**AMENDMENT/ADDENDUM No. #3**

**Solicitation Number:** 2122-26MJ

**Description:** HCS Transportation Training Pad

**DUMPSTER ENCLOSURE**  
NOT TO SCALE

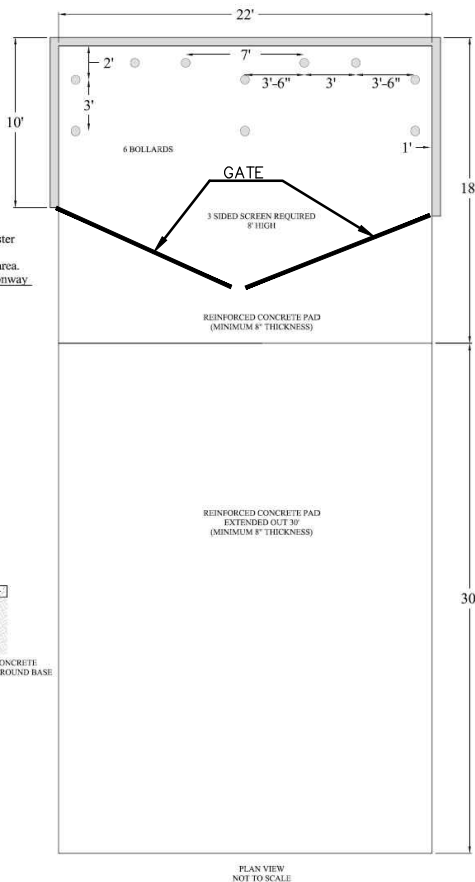
33.	Drawings C-1, C-5 & L-2: Please provide specification requirements outlining type of materials, color, etc., for the 3-sided dumpster enclosure with chain link gates	The contractor needs to include in the base bid the double dumpster enclosure that includes the concrete pad, driveway, footings and the split face blocking – see attachment "A". Horry County Schools will be responsible for the installation of the gates on the front of the dumpster enclosure.

**NOTE:**  
GATE TO BE INSTALLED BY  
HORRY COUNTY SCHOOL DISTRICT
